How to fix Smart Switching Converter PCB problem?

The PCB of the Smart Buck Converter contains two errors:

Figure 1

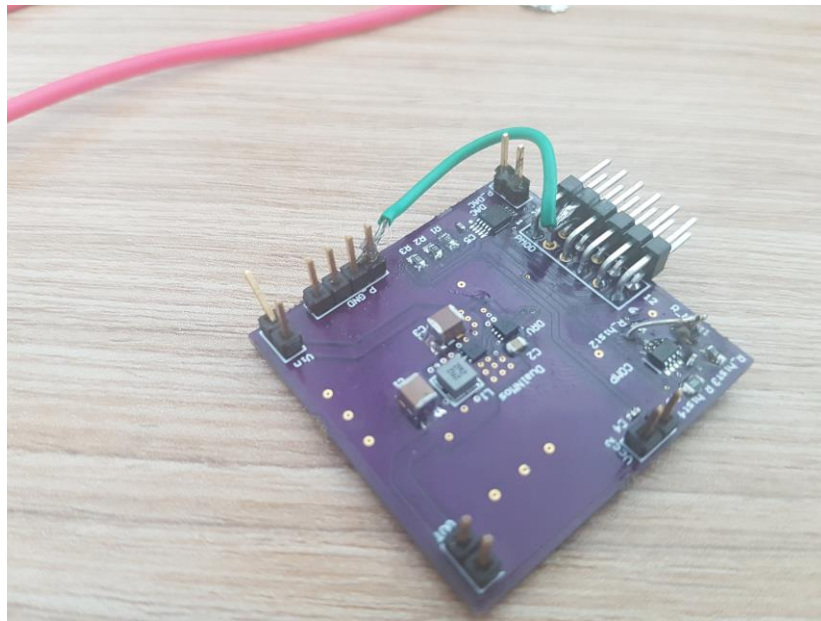
- the PMOD GND pin is not physically connected to the board ground
 - the comparator positive feedback is incorrectly wired
1. The GND problem is very easy to fix: just solder a wire between the PMOD ground PIN and the 1 x 4 board ground pin header (as Figure 1 shows)

Figure 2

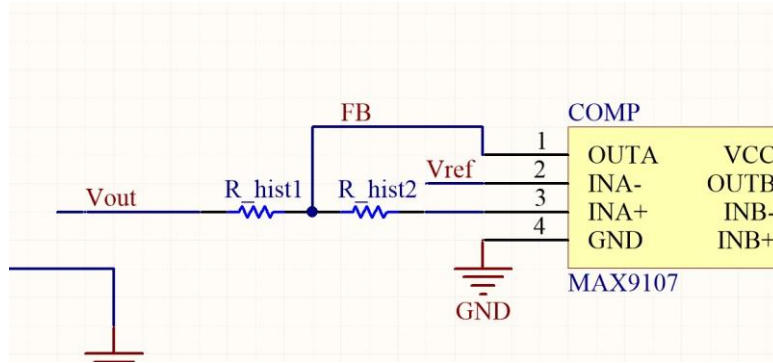
As Figure 2 shows, the R_hist1 and R_hist2 are wrong connected. In this case, R_hist2 has no purpose, because it is in series with the input impedance of the non-inverting input of the comparator.

In order to fix the problem, the right terminal of R_hist2 should be disconnected from IN+ and connected to OUTA. The FB wire should be disconnected from OUTA and connected to IN+.

Figure 3

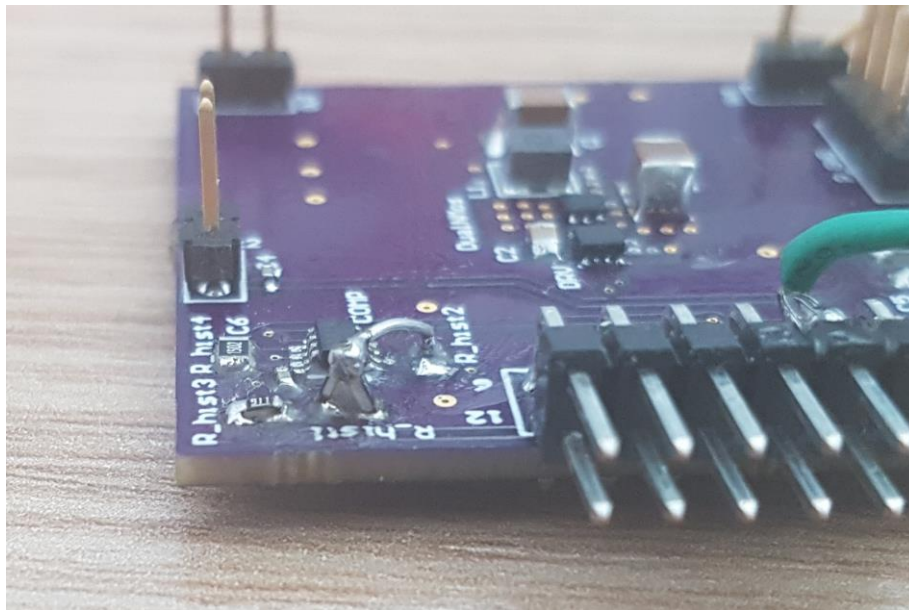
Because this problem is not major one, it can be solved without destroying the PCB.

For doing this, R_{hist2} was detached from its PAD. Both R_{hist1} and R_{hist2} were soldered on the pad of R_{hist1} in a triangle form. R_{hist1} was lifted at 60 degrees, remaining fixed on the upper pad (the one closer to the top border). R_{hist2} was soldered with a terminal on the other pad of R_{hist2} (the one closer to PMOD). Our common pad (which is the triangle top) was soldered, and connected to the right pad of R_{hist2} (see Figure 4).
